MEMORANDUM FOR RECORD

SUBJECT: Visit to Midland Michigan NPP on 27-28 February 1980, A Review of the Midland Plant Units 1 and 2 FSAR (Including Revisions 1-27)

MIDLAND PROJECT -
MIDLAND DOCKET NO 50-329, 50-330
TESTIMONIES OF WC PARIS AND DR RD WOODS

SPT REQUIRED FOR ASSURANCE OF
F.S. = 1.5 AGAINST LIQUEFACTION OF
COHESIONLESS SOILS BY SEED-
DRISS SIMPLIFIED PROCEDURE

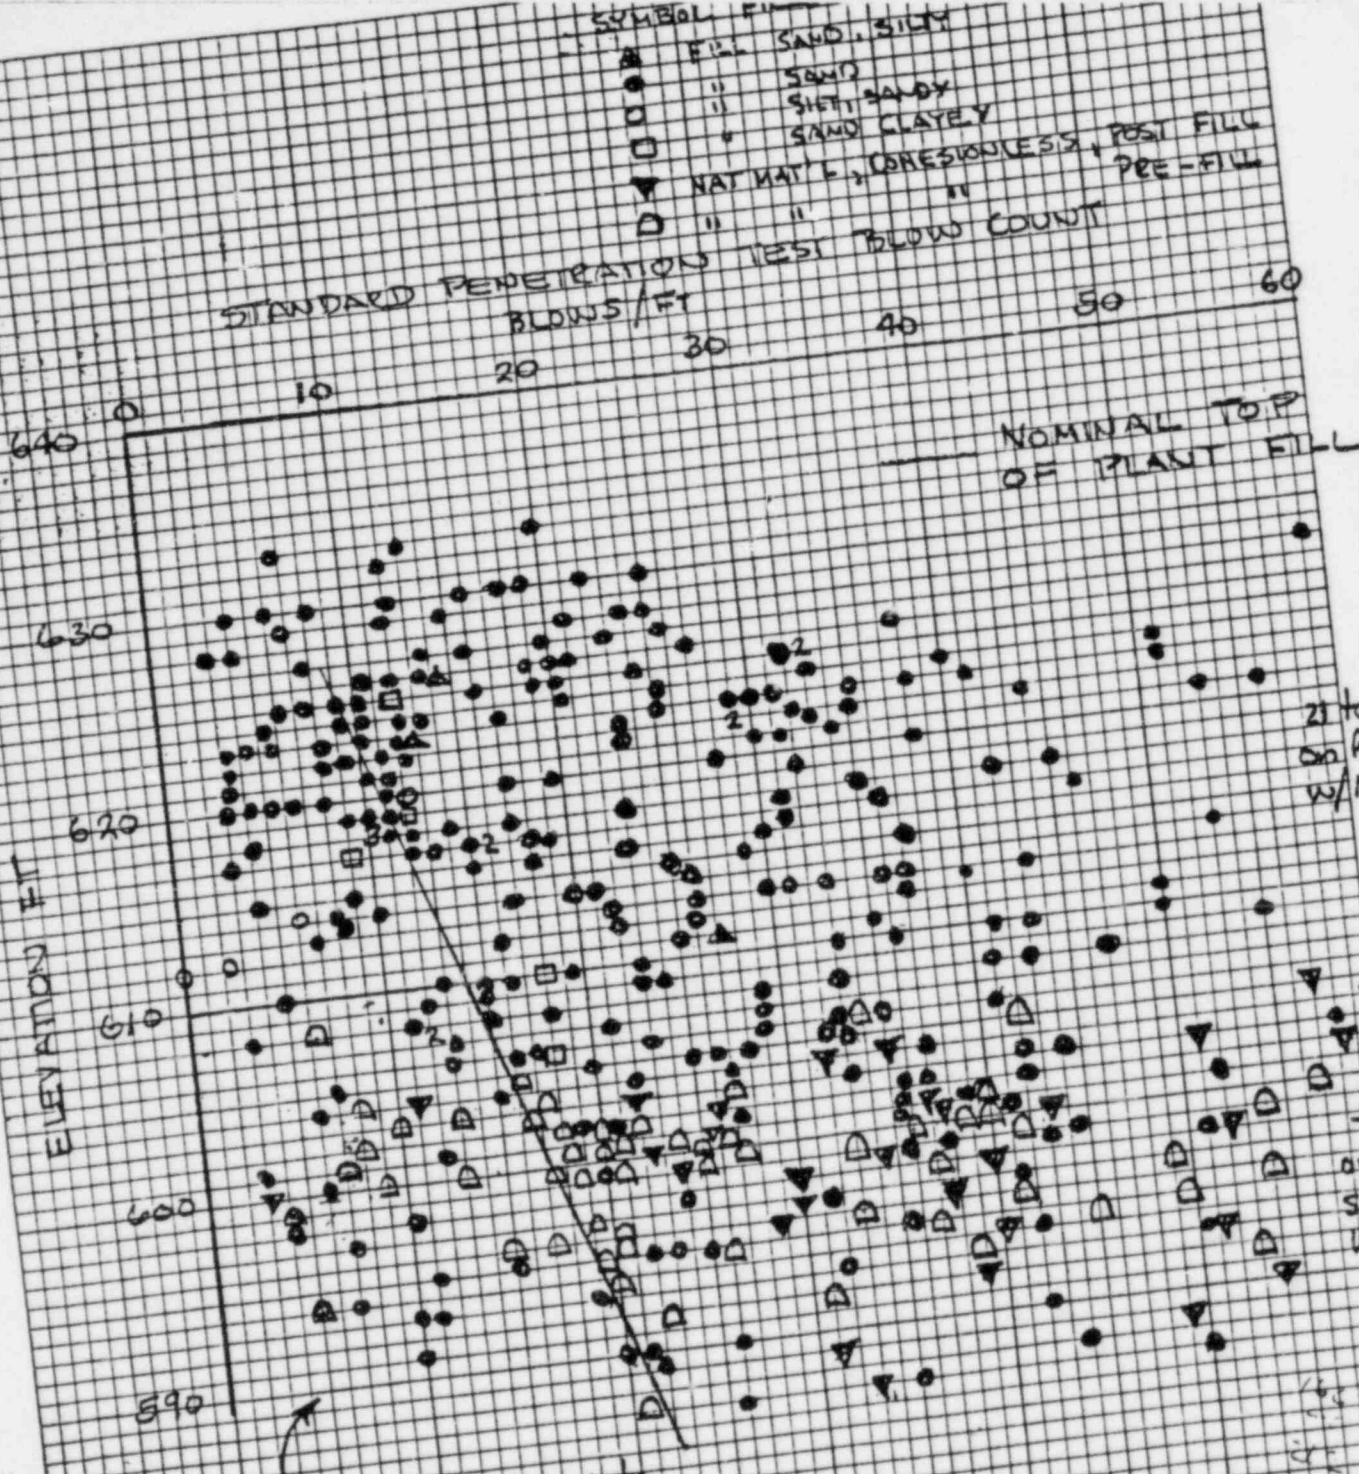
4. An independent Seed-Idriss Simplified Analysis was performed for the fill area under the assumption that the groundwater table was at or below elevation 610. For 0.19 g peak ground surface acceleration, it was found that blow counts as follows were required for a factor of safety of 1.5:

Elevation ft	Minimum SPT Blow Count* For F.S. = 1.5
610	14
605	16
600	17
595	19

The analysis was considered conservative for the following reasons (a) no account was taken of the weight of any structure, (b) liquefaction criteria for a magnitude 6 earthquake were used whereas an NRC memorandum of 17 Mar 80 considered nothing larger than 5.5 for an earthquake with the peak acceleration level of 0.19 g's, (c) unit weights were varied over a range broad enough to cover any uncertainty, and the tabulation above is based on the most conservative set of assumptions. The curve described in the above tabulation is compared to those for other groundwater tables and earthquake loading conditions in Incl 3.

Method - Seed - Idriss Simplified Analysis

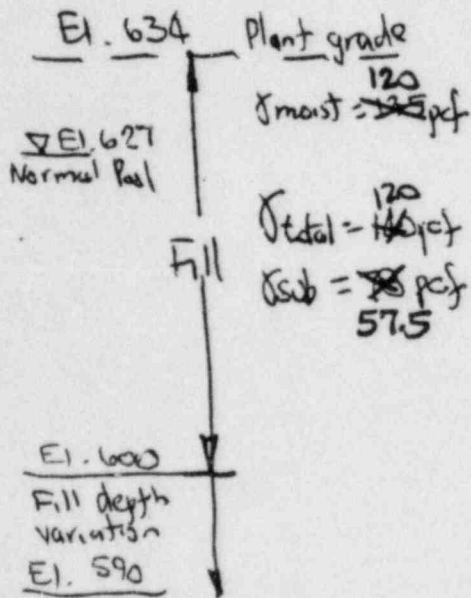
Assumptions - GWT was at or BELOW elev. 610

- Peak ground surface acceleration = 0.19g
- required factor of safety = 1.5 against liquefaction type failure
- Magnitude 6 earthquake

Find - What uncorrected blow count (N) is required to have a F.S. = 1.5 @ El. 610 when GWT is @ Elev. 610 when $a_{max} = 0.19g$?
